Backfeed Adhoc

14 May 2018

Backfeed voltage ... a closer look (single-signature PD)

Figure 3. Typical Reverse Current

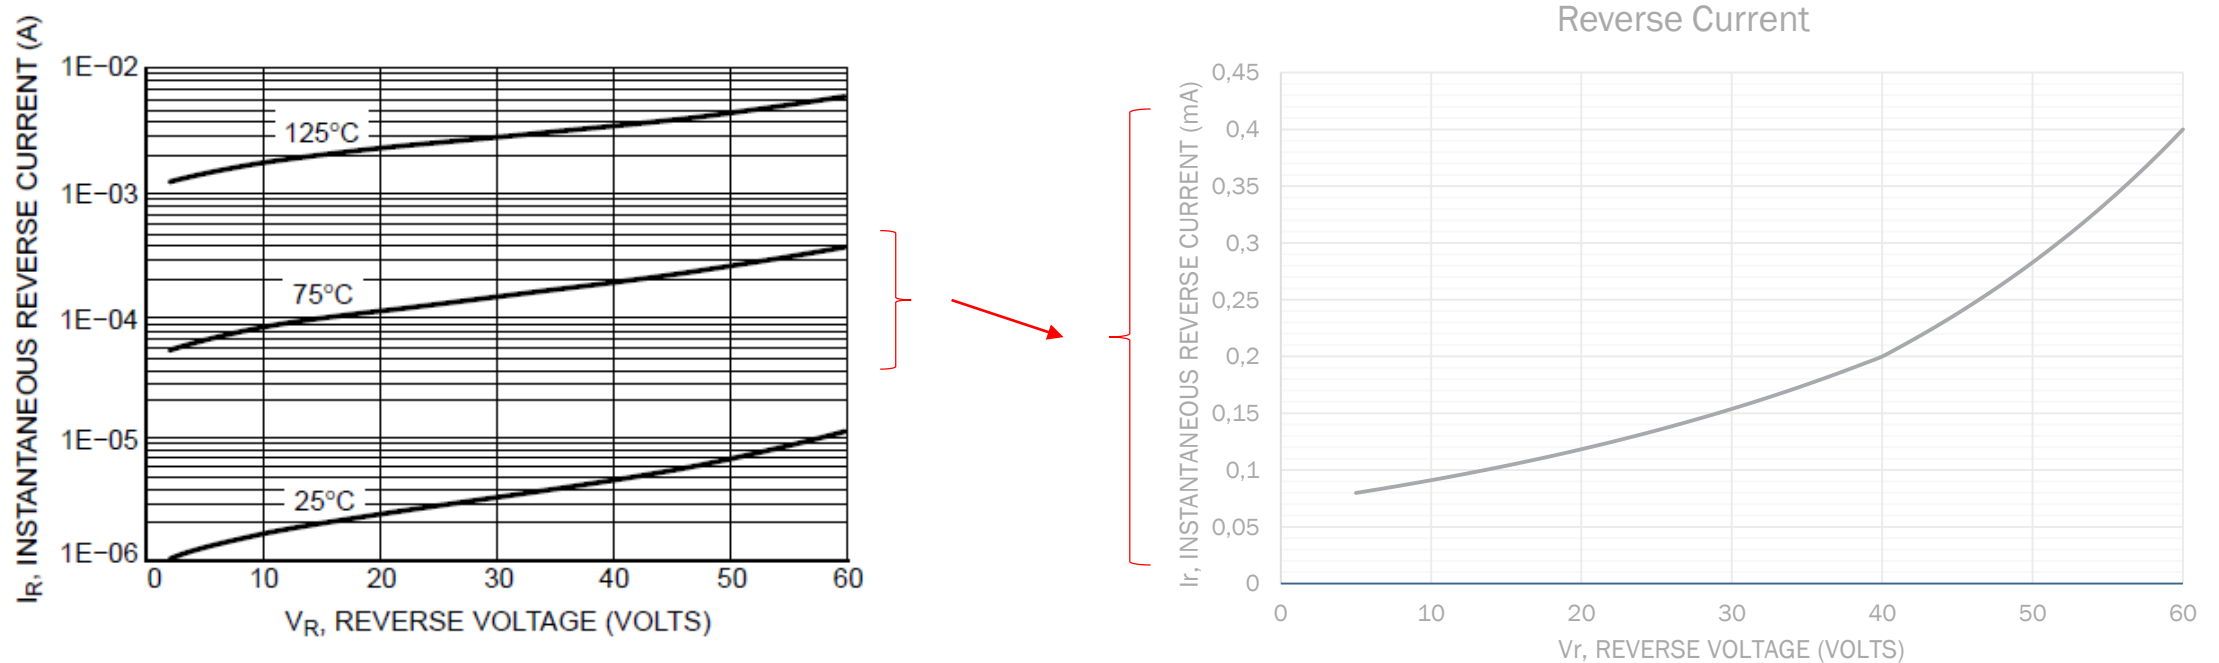
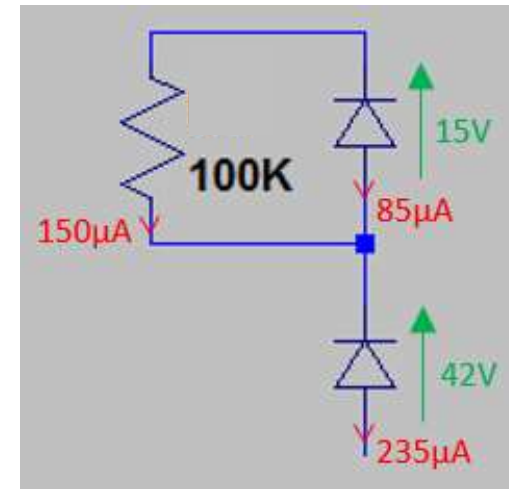
The temperature of the diode bridge on the unpowered pairset will be close to the lead temperature of the diodes conducting the current on the powered pairset.

A lead temperature around 65°C corresponds to a common operating condition (the same temperature is used to specify the max cable DCR – see 145C.3)

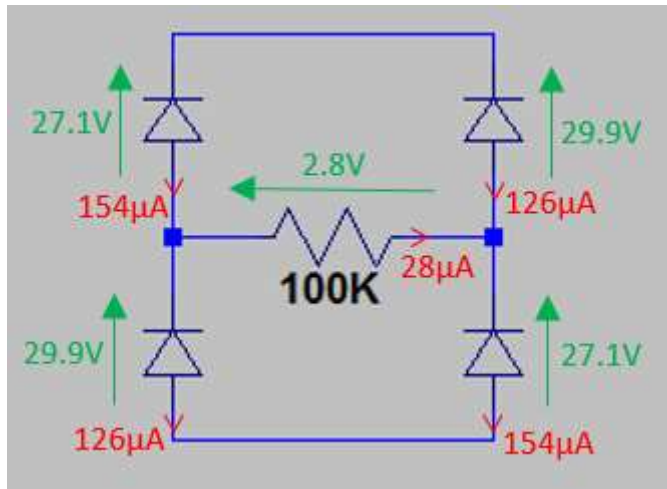
When extending the existing 'symmetrical' backfeed voltage specification to an 'asymmetrical' 3P reflected voltage specification, a significantly larger reflected voltage value can be expected even with PDs using real diode bridges.

Moreover when introducing a backfeed/reflected current specification and furthermore reducing the 100kΩ down to 0 Ω, much larger backfeed/reflected currents than 28μA ($2.8\text{V}/100\text{k}\Omega$) can be expected (e.g. $360\mu\text{A}@57\text{V}$).

The 2P overall schematic (on the left) versus the new 3P overall schematic(s) (on the right).

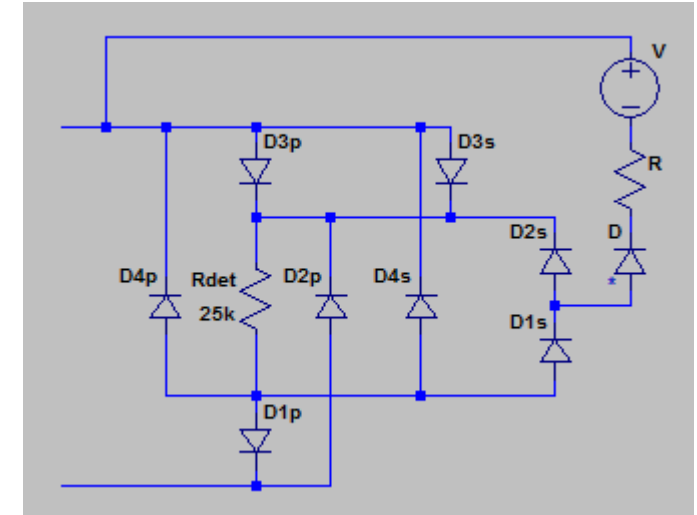
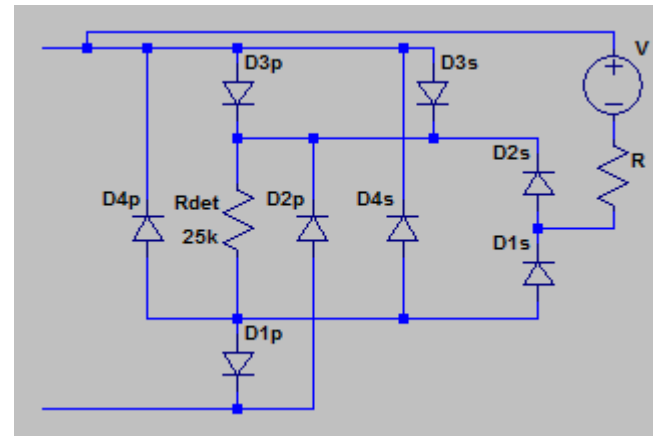
The Schottky diode DC leakage current is usually overlooked !

What should be the V, R and (optional?) D for the other mode of the "3P PSE" ?

(... if any combination is possible anyhow allowing a "3P PSE")

Measurements - 1

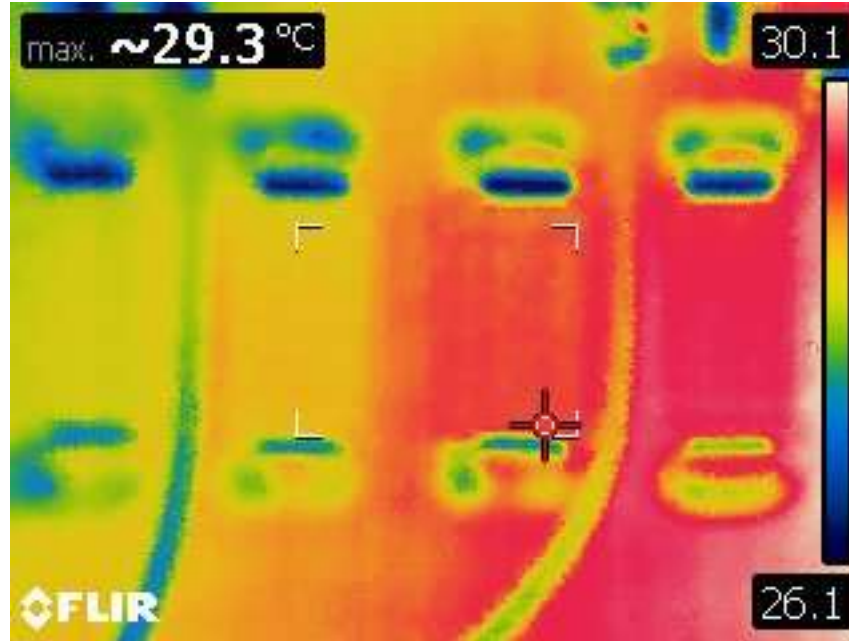
$V_{bfd} = 6.73\text{mV} @ 10\text{V}$

$V_{bfd} = 47.2\text{mV} @ 57\text{V}$

3P Reflected voltage over $100\text{k}\Omega$:

113mV and $123\text{mV} @ 10\text{V}$

57V : 2.12V and $2.4\text{V} @ 57\text{V}$

Perfectly OK for the existing backfeed voltage specification with huge margin:

$0.0472\text{V} \ll 2.8\text{V}$

Coming close to the limit if 3P reflected voltage would be extended to a high voltage.

Measurements - 2

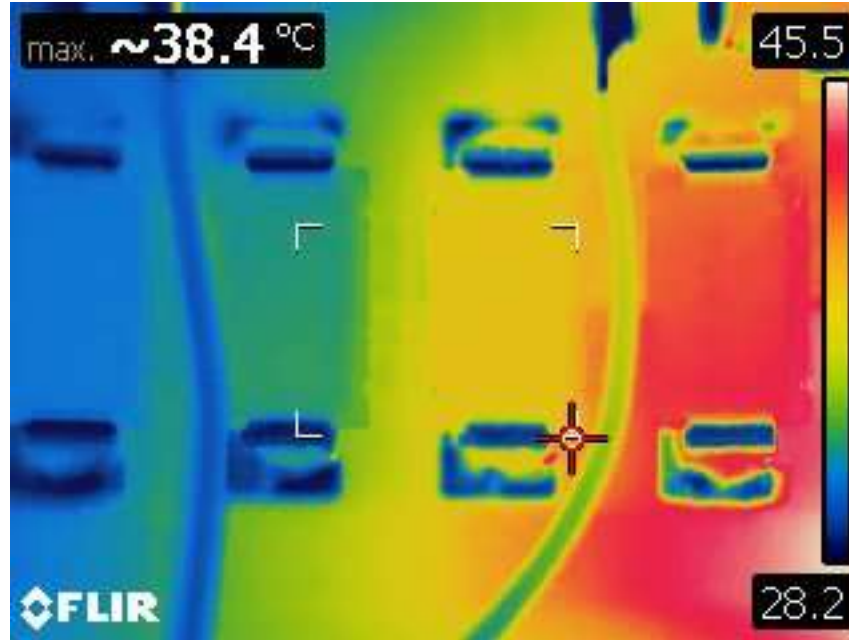
$V_{bfd} = 7.65\text{mV} @ 10\text{V}$

$V_{bfd} = 33.4\text{mV} @ 57\text{V}$

3P Reflected voltage over $100\text{k}\Omega$:

108mV and $127\text{mV} @ 10\text{V}$

2.4V and $3.34\text{V} @ 57\text{V}$

Perfectly OK for the existing backfeed voltage specification with huge margin :

$$0.0334\text{V} \ll 2.8\text{V}$$

Would go above the limit if 3P reflected voltage would be extended to a high voltage.
